St. Cronan's Avenue & Brackenstown Road Protected Cycle Lanes

Public Engagement Report

Fingal County Council

May 2022

Cronans Ave:

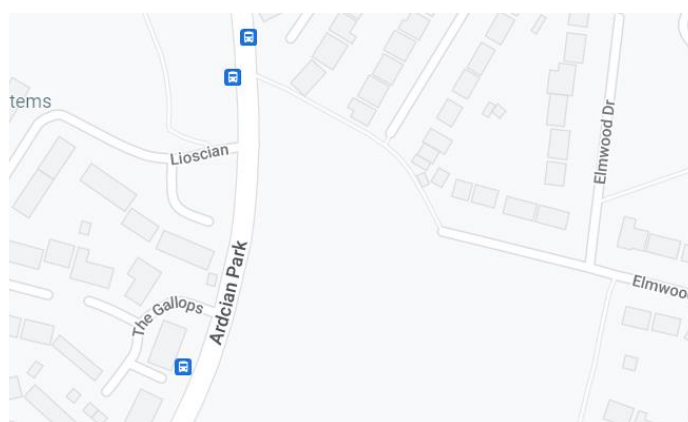
Was consideration given to putting the bike lane inside the tree line on St Cronan’s Ave south of Ardian Park given there is space available? This would be best practice in Netherlands to have a grass strip between bike lane and road. Would be a more permanent solution over bollards.

There does not appear to be Bus stop bypass in the designs for bike lane. This is certainly a risk on St Cronans Ave given speeds motor vehicles travel at. Could these be included in a future phase please?

While it may be possible to provide the cycle track between the trees at this location, other pinch points along the route mean it cannot be replicated for the full extent of the project. Weaving on road and off road may induce complacency by either cyclists or drivers and it is preferable to have consistency along the project. The NTA active travel proposals emphasise the reallocation of existing road space for the following reasons:

The provision of bus stop bypass for cyclists requires a significant amount of space to provide a landing area, cycle track and footpath. More experienced cyclists can choose to route around the bus when stopped and less experienced cyclists can choose to wait.

Intersection of Brackenstown road and St Cronans Ave.

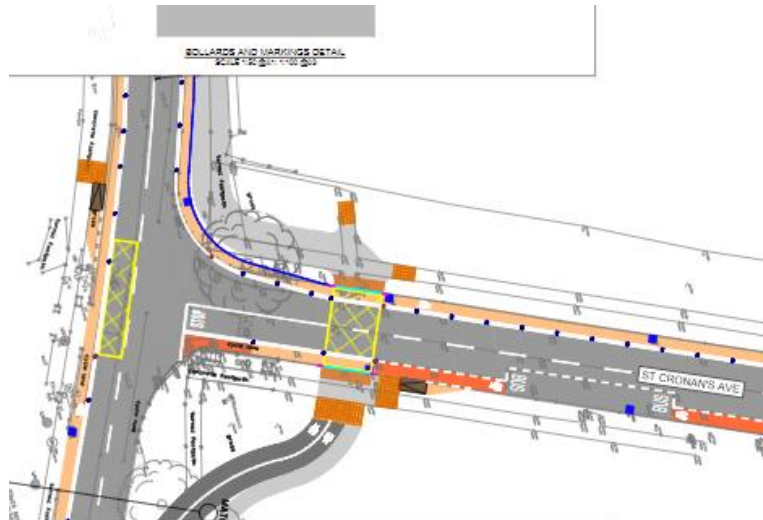
Was consideration given to a Dutch type Roundabout at junction of St Cronan's Ave and Brackenstown Ave? This would facilitate safe walk and cycle routes and also reduce the delay for cars turning right from Cronans Ave onto Brackenstown Ave. It would also calm car speeds on the Brackenstown Ave at this location. On the Webinar the designers mentioned that this was not in scope for current works but could be a consideration for future phase in this area.

For cars heading south on Cronans Ave to this intersection could consideration be given to a right and left turning lane for cars and routing the bike lane off the road. This can be a bottleneck at rush hour for cars and a dangerous intersection for bikes. A new pedestrian/bike raised crossing across Brackenstown Ave could be installed at this location (East of the junction).

The reconfiguration of the St Cronan's Avenue junction with Brackenstown Road was originally outside the scope of the project. A design review will be conducted as part of the detailed design process in the current design and build contract.

Brackenstown Road

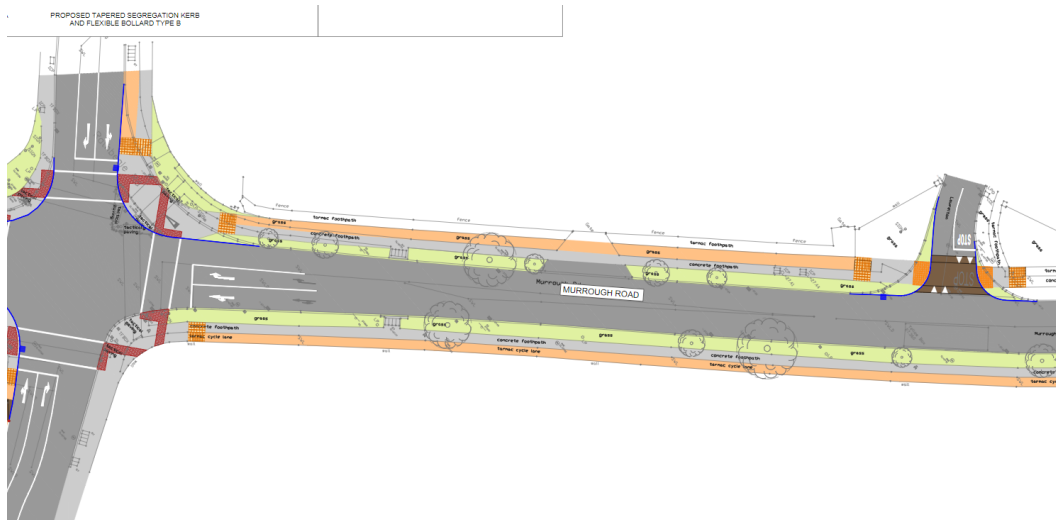
A 2-way bike lane on this stretch up to Parkview could also have worked well given space available and would provide a safer option. Co-ordinate this with better crossing at exit points from Swords Manor.

Risk that bollards in the current plan will not stop from parking at entrance to Soccer pitches in Swords Manor. This could be one area where kerbs may be necessary. Most of the other areas in the plan that are provided with bollards are not subject to parking in the bike lane so bollards should be sufficient.

No Cycle lane marked on this section of the drawing. Presume this is just an error with the drawing.

The issue with parking across the protected cycle tracks will be monitored following construction of the project and alternative measures implemented if considered necessary.

The orange / peach colour on the section between Rathbeale Road and Laurelton is the proposed cycle track. It will be constructed through the existing grass verge to avoid impacting the existing trees. The "grass" reference is the topographical survey indicating its existing form.

Intersection of Brackenstown road and St Cronans Ave.

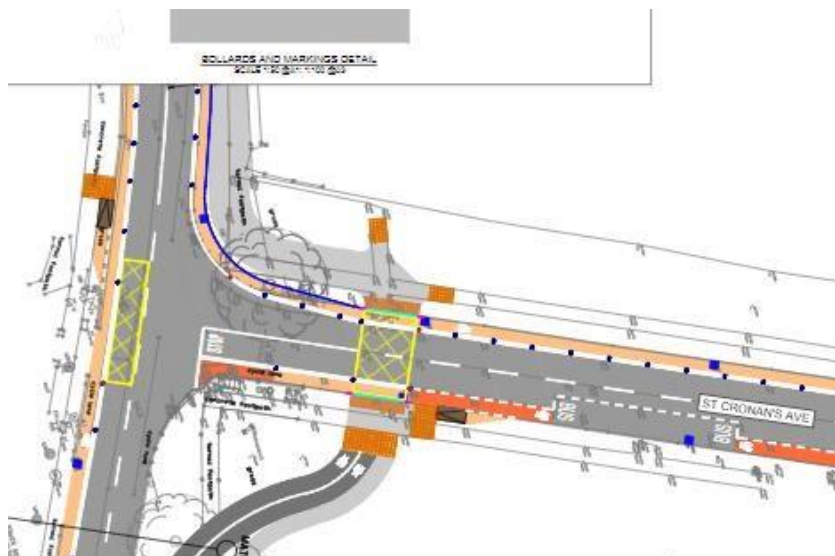
A Dutch style Roundabout (diagram of one proposed for Dublin 15 below) at junction of St Cronan's Ave and Brackenstown Ave should be strongly considered. This would facilitate safe walk and cycle routes whilst reducing the delay for cars turning right from Cronans Ave onto Brackenstown Ave. It would also calm car speeds on the Brackenstown Ave at this location. In the Webinar, the designers mentioned that this was not in scope for current works but could be a consideration for future phase in this area.

For cars heading south on Cronans Ave to this intersection could consideration be given to a right and left turning lane for cars and routing the bike lane off the road. This can be a bottleneck at rush hour for cars and a dangerous intersection for bikes. A new pedestrian/bike raised crossing across Brackenstown Ave could be installed at this location.

The footprint of a Dutch style roundabout is quite large and would require significant design and construction inputs. The roundabout has been proposed as a means to overcome difficult sightlines from Lioscian looking north when a bus is stopped at the bus stop. The lanes on approach to the roundabout will be narrowed to 3m to slow traffic on approach to the roundabout, and the geometry constrained by tightening corner radii. Roundabouts only require vehicles to yield from the right, thereby eliminating the sightlines issue without the need for planning permission to move the bus stop.
